# ROADSTER 2010-12 Fuel Vapor Canister Vent Hose Inspection-Replacement\_000043672\_WSC61Y010S02\_en

Bulletin type: **Safety Campaign**

Bulletin no: **2010-12** (rbg2010-013 en AP)

Subject: **Fuel Vapor Canister Vent Hose Inspection/Replacement**

**FUEL VAPOR CANISTER VENT HOSE**

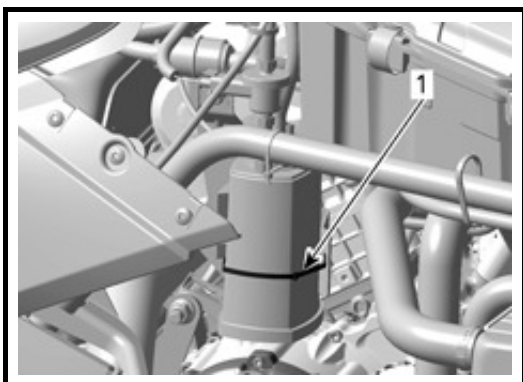
If the correct hose is installed and properly routed, no future action is required. This hose is preformed and must have the following shape. Reinstall all removed parts and go to WARRANTY procedure.

If another hose is installed, remove and discard it before installing the correct hose.

1. Preformed vent hose (P/N 709 000 277)

A. Approximately 480 mm (18-7/8 in)
